**Cultural Heritage Impact Statement
231 Cobourg Street, Ottawa**

Report Prepared for: **Ten 2 Four Architecture Inc.**
RMA Project No.: **17008**
Date: **November 22, 2017**

Annex A	Existing Conditions
Annex B	Design Package R2
Annex C	City of Ottawa Review Comments & Response
Annex D	Heritage Survey and Evaluation Form
Annex E	Wilbrod/Laurier HCD Plan

DRAWING TITLE:
Proposed Site Plan

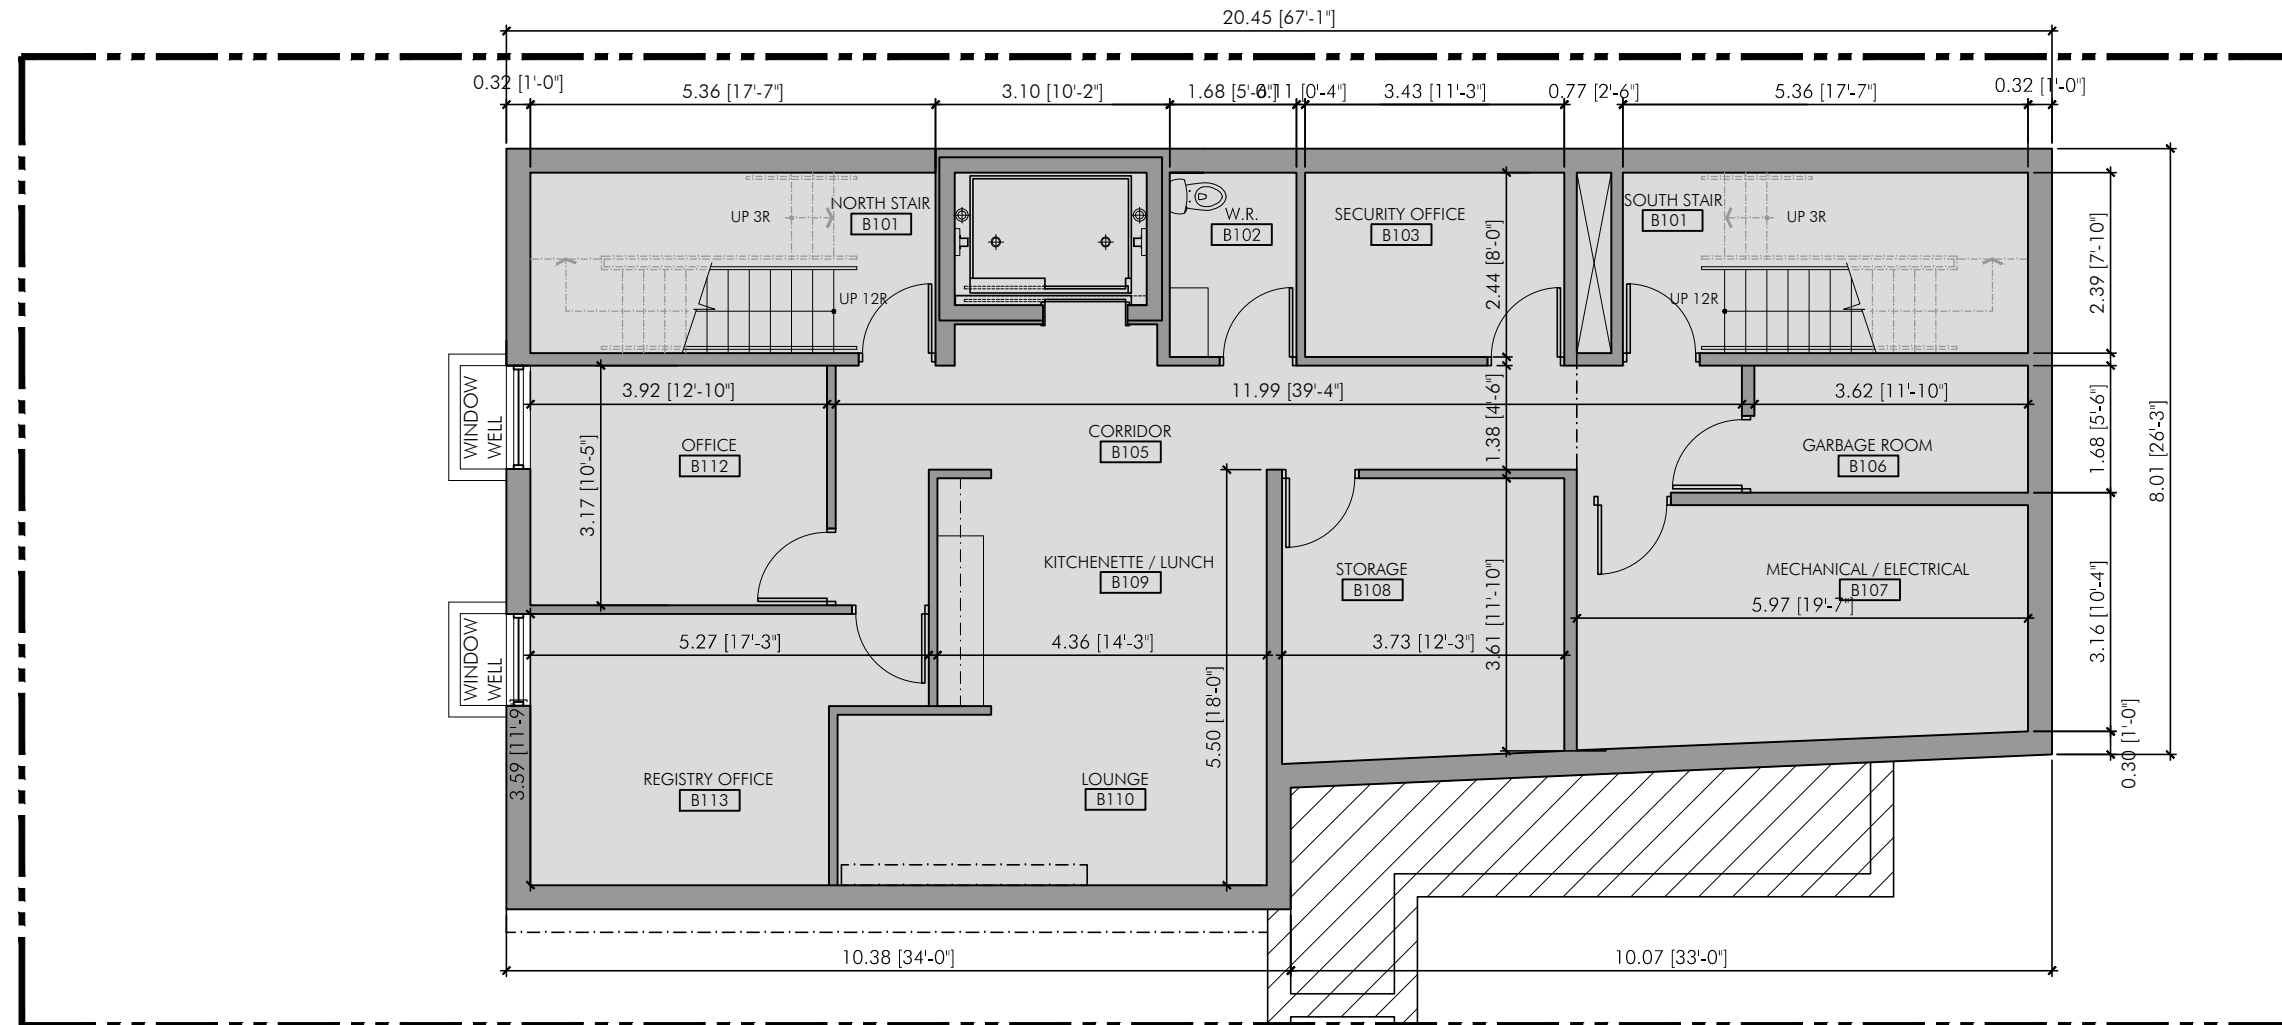
- 12. Site plan requires a note stating where the underlying property boundary information as derived from and how it was referenced to the topographic detail

Derivation information for the property boundary information has been added to Site Plan drawing A1 (Issue No. 9 dated Nov. 22, 2017). Referenced survey drawing has been re-issued.

PROJECT NO:
 A14014
 DRAWING TITLE:
Proposed First Floor Plan

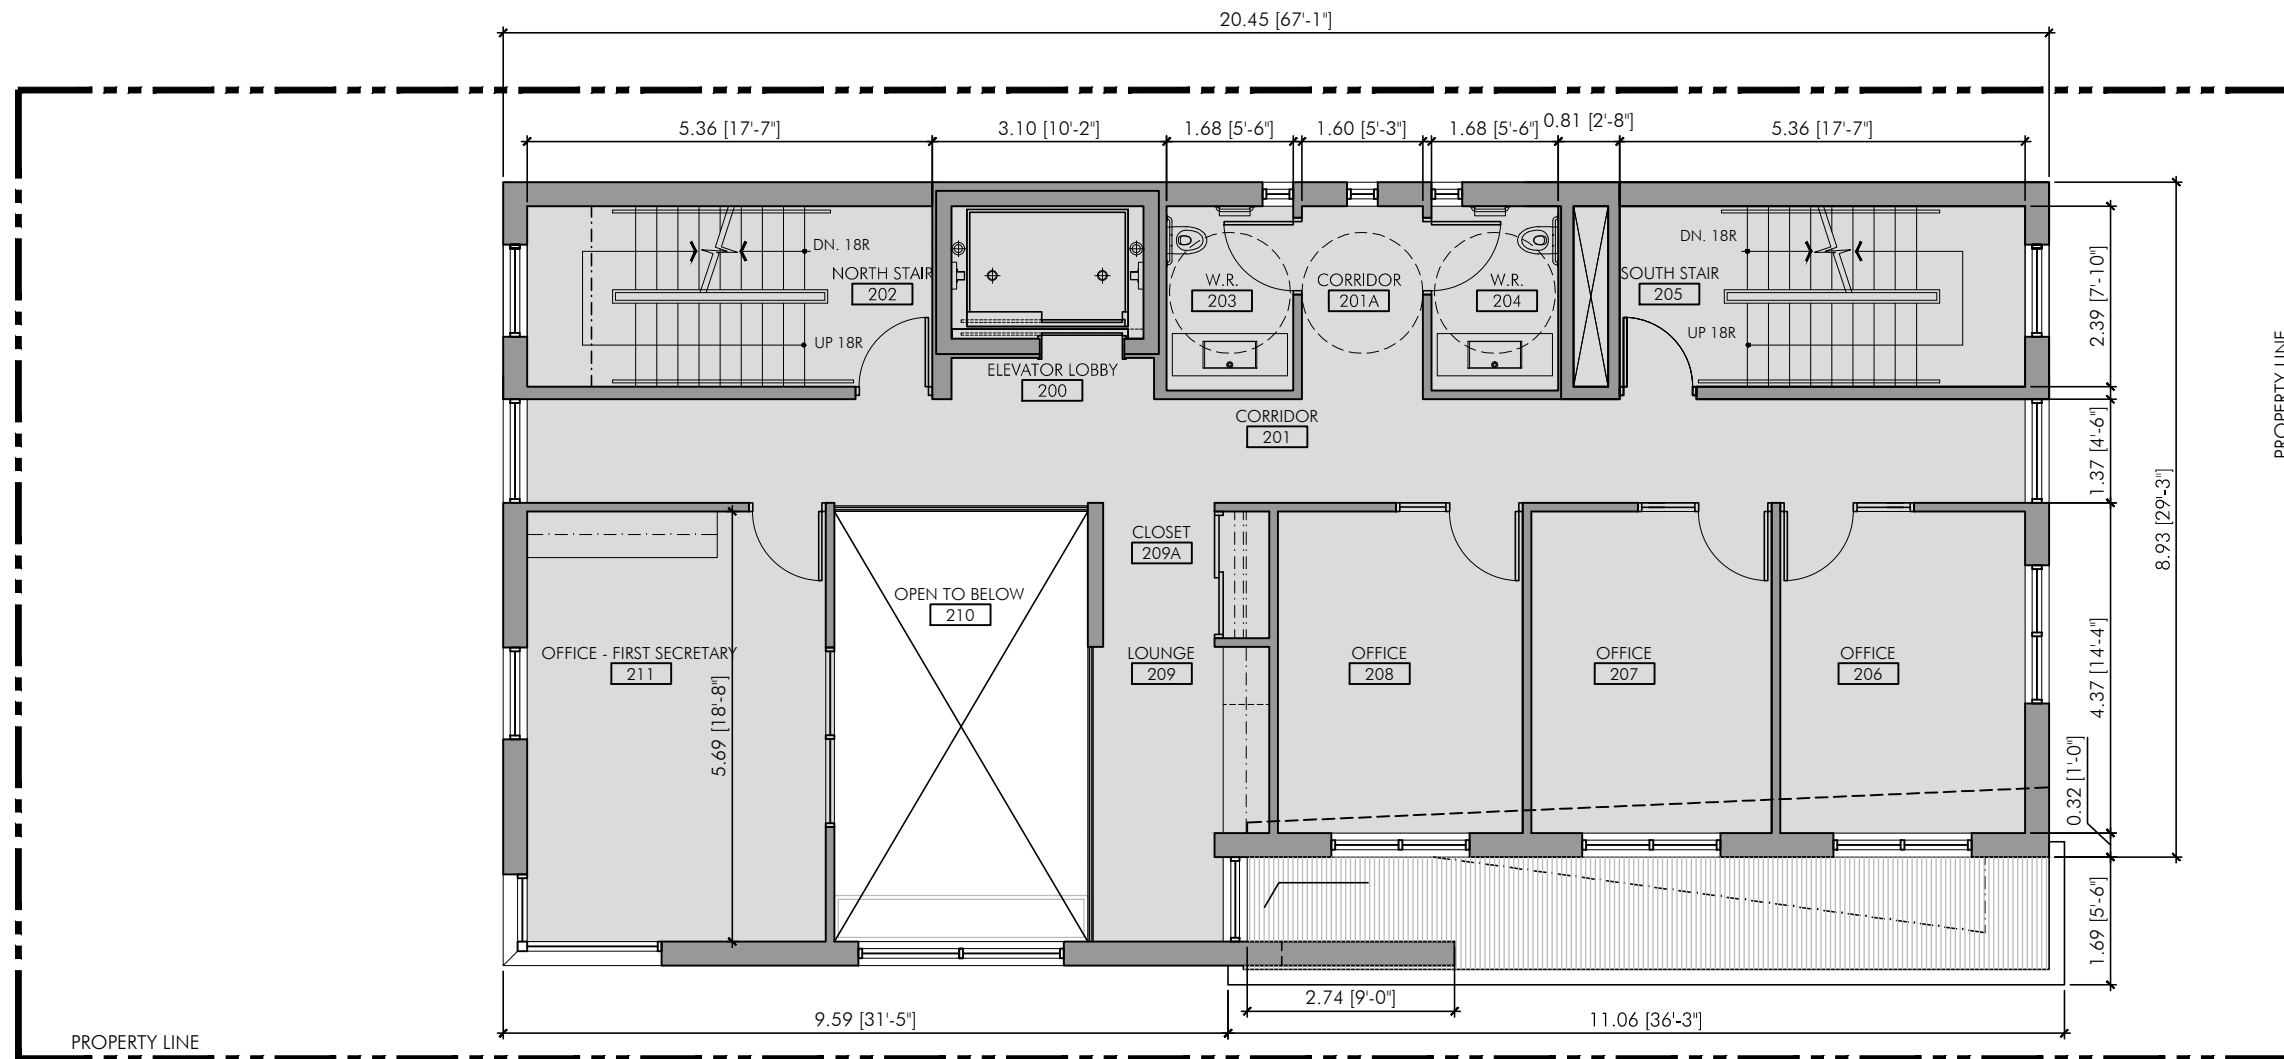
5. Consider a single staircase along the Cobourg Street entrance. The second set of stairs seems to remove other opportunities for landscaping.
6. If the ground floor is lowered (even to grade) the ramp length can be reduced by half or altogether, significantly reducing its impact on the streetscape. Currently the entrance to the ramp is in a location farthest from the main entrance and parking which means that access could be restricted in the winter months because wheelchairs would not be able to traverse the snowy sidewalks between the parking and the ramp;

The ground floor has been lowered and the ramp has been substantially reduced. The ramp entrance is now significantly closer to the main entrance and has a better relationship to the front of the building. Please refer to architectural drawing A3 – Proposed First Floor Plan (Issue No. 9, dated Nov. 22, 2017)

Basement windows on the north side have been revised to incorporate window wells. Please refer to architectural drawing A3 – Proposed First Floor Plan (Issue No. 9, dated Nov. 22, 2017)
